**2023–15–05 The Boeing Company:**

Amendment 39–22517; Docket No. FAA–2023–1650; Project Identifier AD–2023–00795–T.

**Figure 1 to paragraph (g) - Engine anti-ice AFM revision**

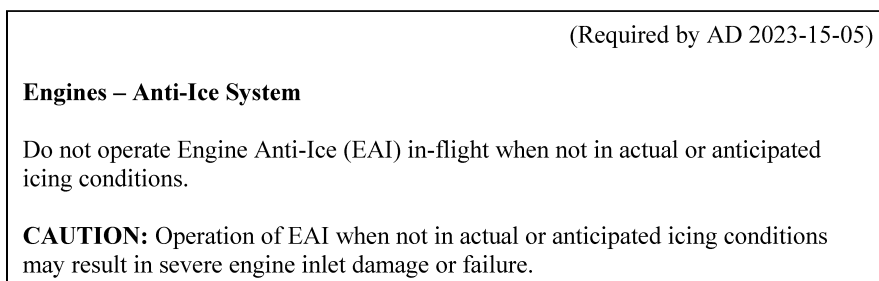
Within 15 days after the effective date of this AD: Revise the Limitations Section of the existing AFM to include the information specified in figure 1 to paragraph (g) of this AD. This may be done by inserting a copy of figure 1 to paragraph (g) of this AD into the existing AFM.
